**PLANNED UNIT DEVELOPMENT &
SUBDIVISION STAFF REPORT**

Date: May 15, 2003

DEVELOPMENT NAME Hillcrest Trace Subdivision, Revised

PLANNING COMMISSION VICINITY MAP - EXISTING ZONING

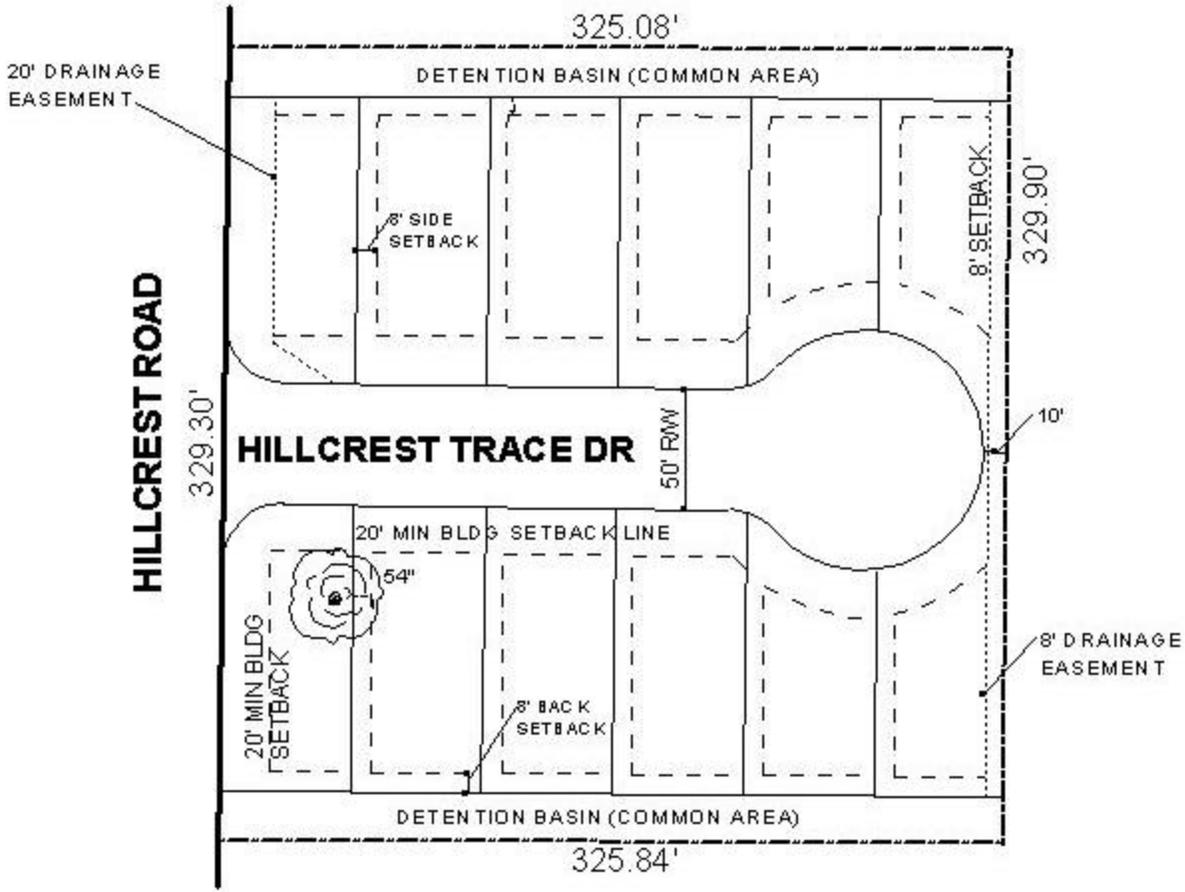
The site is surrounded by single family residential dwellings.

TYPICAL LOT

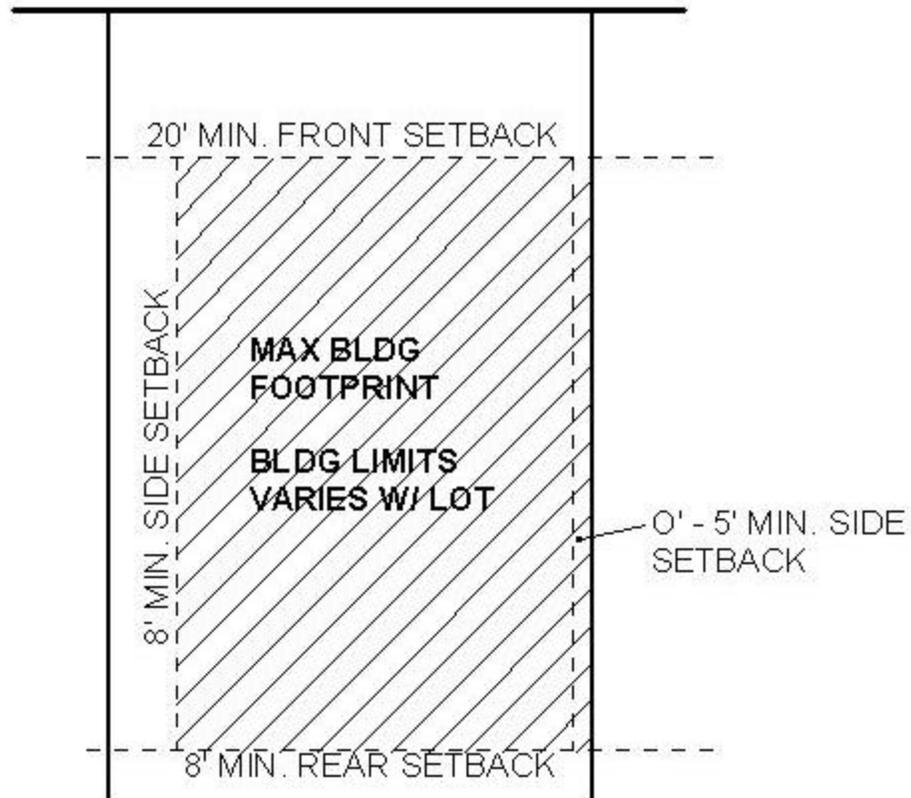
The applicant is requesting amended Planned Unit Development (PUD) approval to increase the maximum site coverage to 55% per lot and to reduce the front building setback lines from 25-feet to 20-feet. These modifications would also alter the record plat, thus a new subdivision approval is required.

In regard to the reduced front yard setback, in a residential PUD a 20-foot front yard setback is common. Additionally, single-family residential PUD applications frequently request increased (more than 35%) site coverage; however, additional site coverage requests typically do not exceed 45 percent. The applicant is requesting 55 percent.

Site coverage is calculated for each individual lot, and as proposed up to 55% of each lot could be covered with a building footprint. It should be noted that only the footprints of the building structures are used to calculate site coverage; the impervious area of the lots (such as driveways, patios and sidewalks) are not included in the site coverage calculations, thus the impervious area of each lot would actually exceed 55 percent.

RECOMMENDATION **Planned Unit Development:** Based upon the preceding, it is recommended that the reduced front yard setback request be approved, and that the increased site coverage request be denied.

Subdivision: The plat meets the minimum requirements of the Subdivision Regulations and is recommended for Tentative Approval subject to the following condition: 1) placement of a 20-foot front yard setback on the final plat.
